PARAMOUNT ARM SHIM KIT FOR THE PARAMOUNT LONG ARMS

Models: Paramounts built prior to September 1, 2008.

Purpose: To prevent the awning from over extending causing the arm elbows to lock out.

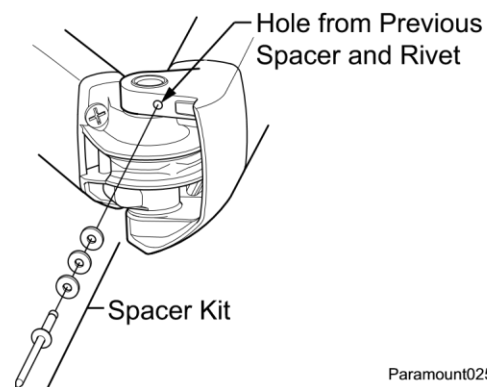
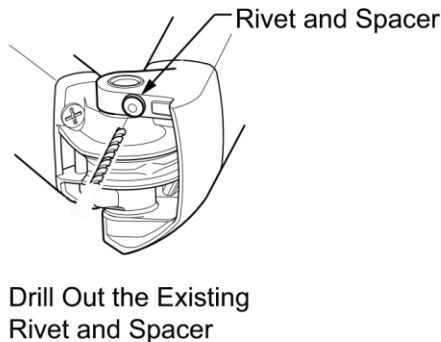
Summary of Work: For each arm: Remove existing spacer from elbow, add additional spacers.

1. Open the awning 12"-14" past the slide out room position to provide access to the long arm elbows.
2. Using an 1/8" drill bit, drill out the existing rivet and spacer and discard.

3. In the existing hole, attach the three (3) spacers to the elbow using the furnished pop rivet.
4. Repeat for both arms.
